DOCUMENT 009113 – ADDENDUM #1

- A. Project Name: Infrastructure Upgrades
- B. Owner: St. Joseph Public Schools
- C. Designer: AE Tech Design
- D. Designer Project Number: SJPS2304-0300
- E. Date of Addendum: 1/16/2024

5 Saint Joseph HS Mech. Mezzanine Technology Plan - Unit F  
10/17/12

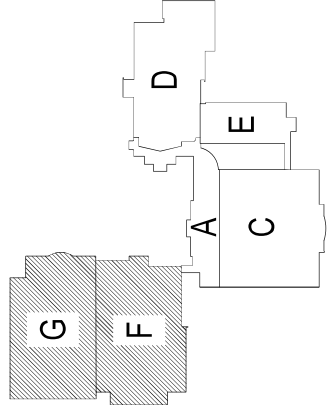
- b. “Work Scope Legend” updated.
  2. Drawing T106B “Saint Joseph HS Main Floor Technology Plan – Unit F & G” – Dated 01/16/2024 (Reissued)
    - a. “Saint Joseph HS Mech. Mezzanine Technology Plan – Unit F” view added to sheet.

St. Joseph's Middle School  
SJHS Inner-Building Backbone Cabling Riser  
WTS

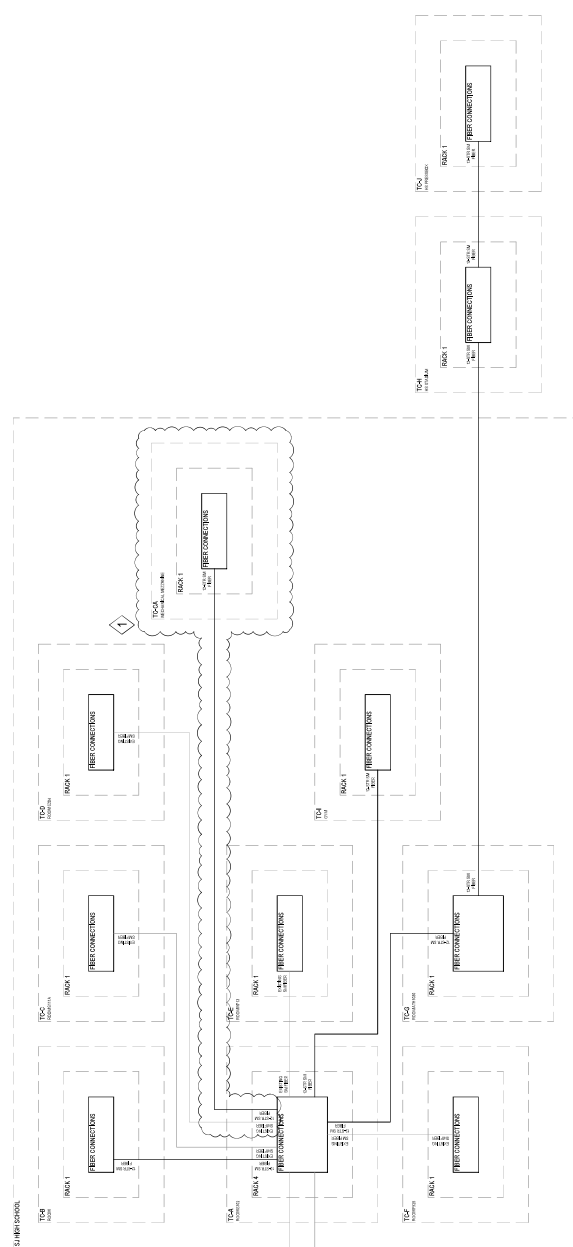
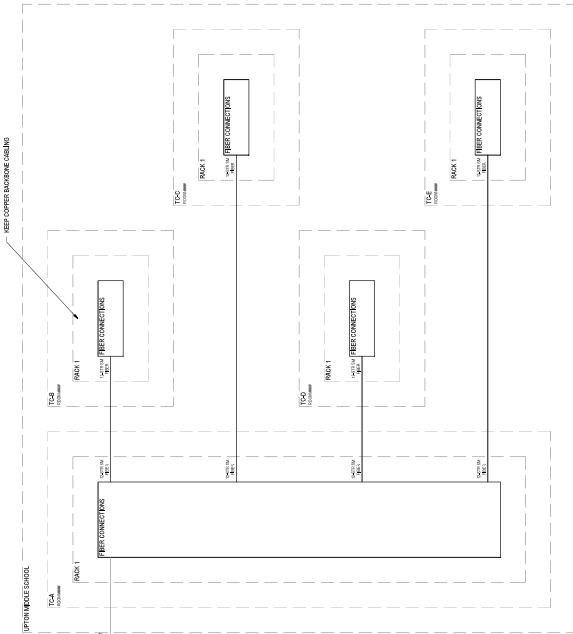
- c. Keyed note #2 was added to racks with UPS that are to be rack mounted.
    - d. SJHS TC-CA rack elevation and details were added.
  7. Drawing T306 "Structured Cabling Details & Risers" – Dated 01/16/2024 (Reissued)

- a. Fiber connection to TC-CA was added in the "SJHS Inner-Building Backbone Cabling Riser."
  8. Drawing T308 "Network Diagram" – Dated 01/16/2024 (Reissued)
